Town of Essex, Vermont
Application for Zoning Permit
 www.essex.org

Application Date 9/4/08
 Permit Number 2008-122

Subject: Proposed Addition to Your Existing Residence Located at 3 Prescott Street Road in the Town of Essex, Vermont.

F Diagram - Provide diagram here and include all setbacks

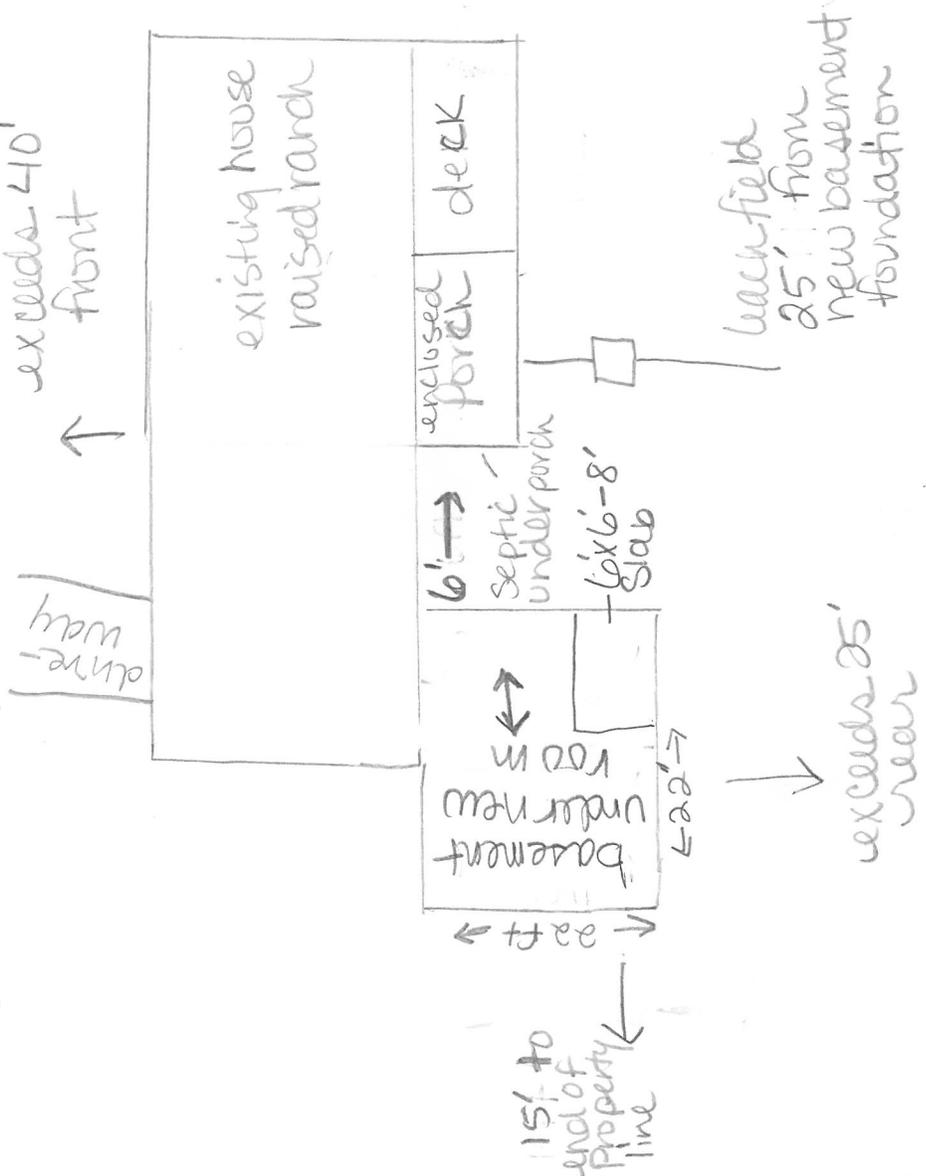
- addition 20' x 22'
- 6ft from edge of septic.
- existing 3 bedrooms remodel will enlarge 2 bedrooms.
- master bedroom will be relocated into new addition
- NO bedrooms added.
